Reply to "RC1: 'Comment on essd-2025-745', Moritz Koch"

Reply to "RC2: 'Comment on essd-2025-745', Anonymous Referee #2"

Figure 3: Here I have three comments,

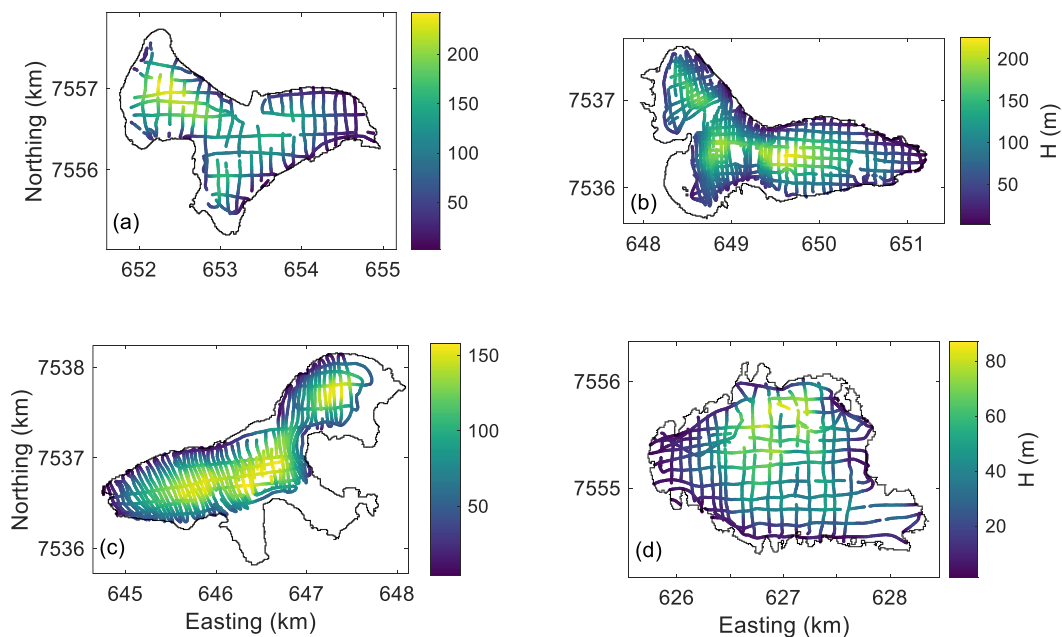
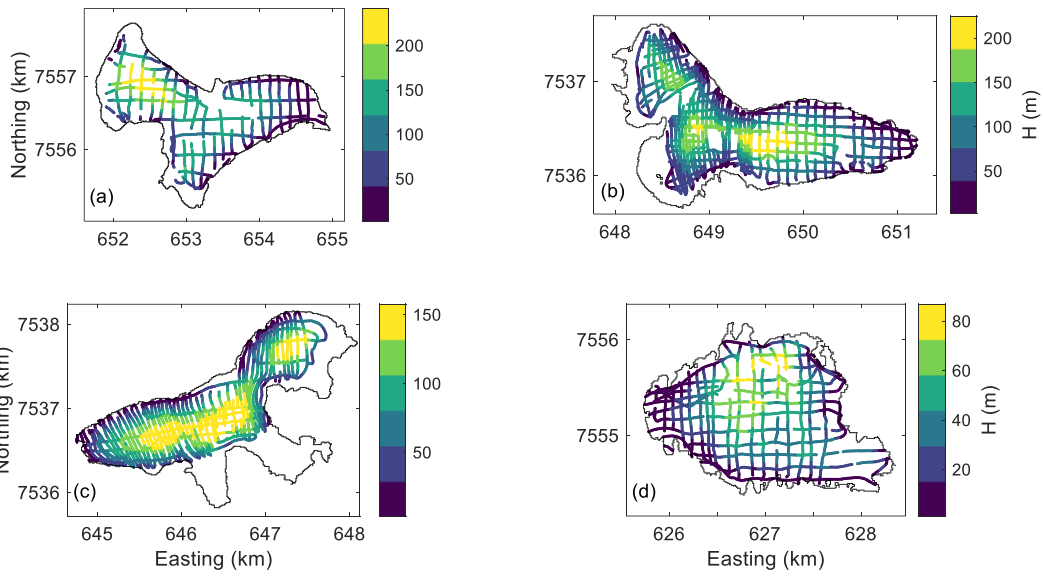
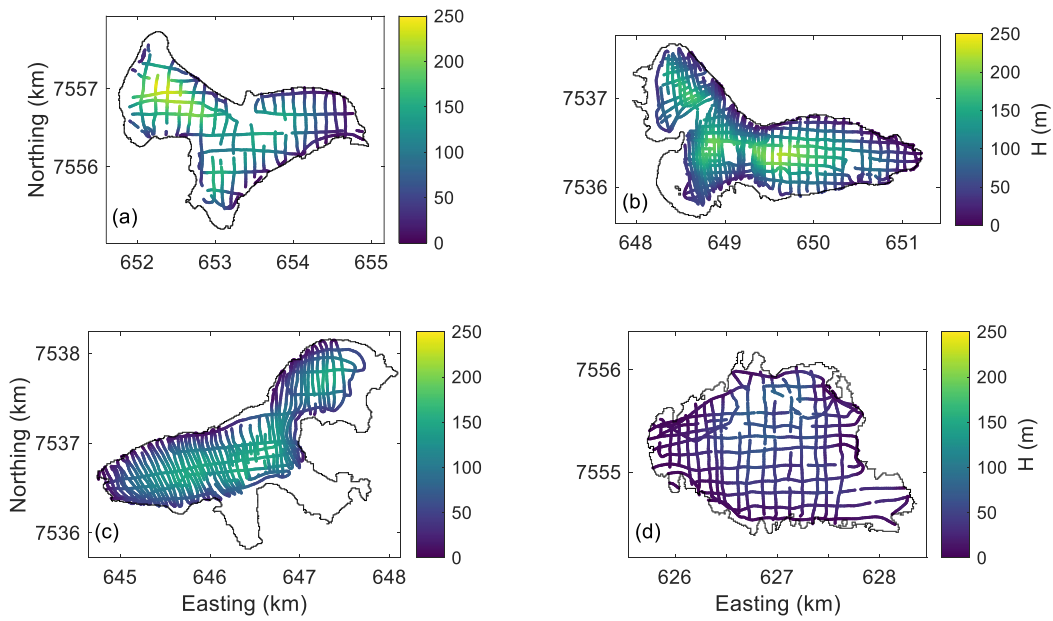
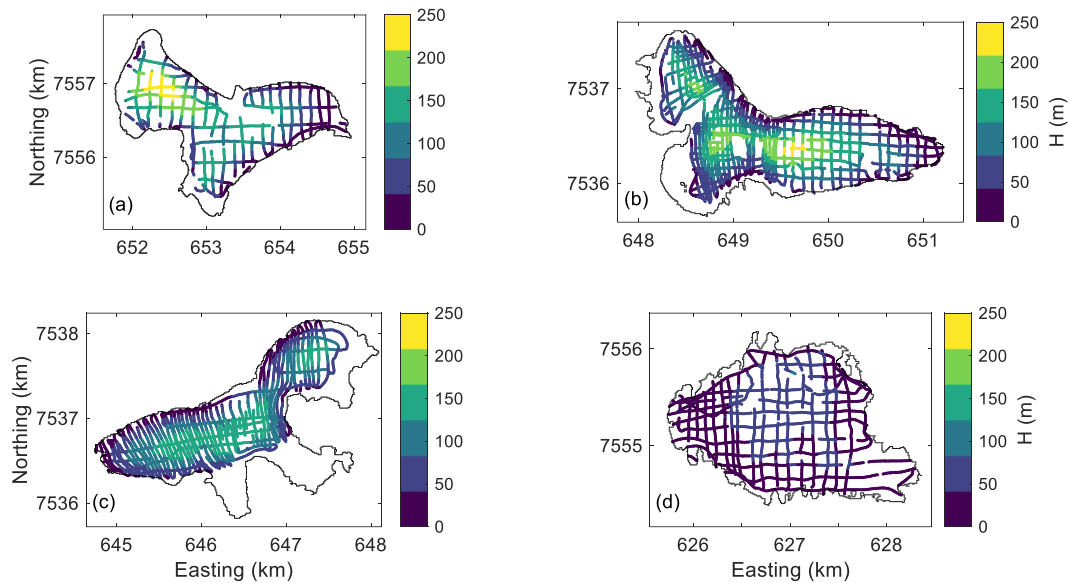
on ice thickness and the Viridis or Parula color palette (among others) has been used both in the order you present here as well as inverted. As such, this comment is more a general appraisal on the lack of consistency in the use of color palettes in the field than critique on the chosen approach here. Nevertheless, the use of the Parula color palette as you apply here is unfortunate as a very similar shade of yellow appears twice along the scale (lower and higher than orange).

We thank the reviewer for this thoughtful comment. We agree that the clarity of the previous figure panels could be improved. Taking into account this comment together with the related suggestions from another reviewer, we have made the following revisions: I) We have simplified the figure by retaining only the measured ice thickness and total point uncertainty in this figure, while moving the individual uncertainty components (previously shown in panels e–l) to the appendix. This improves the readability of the main figures; II) We have replaced the Parula colormap with the Viridis colormap to avoid repeated yellow tones and improve visual distinguishability across the scale; III) We have changed the continuous color scale to a discrete color scale.

We also agree that consistent color scales can enhance comparability between panels. However, as the four glaciers are independent systems with different ice thickness ranges, applying a consistent color scale would reduce the visibility of spatial variations within individual glaciers (We have plotted glacier ice thickness as examples to compare the visual effects of different color scales in Figs. R1–4), especially for RIV that holds much shallower ice. Whereas their individual thicknesses are what we would like to emphasize in this manuscript. Therefore, we have retained color scales with different ranges to better highlight the internal variability of each glacier.
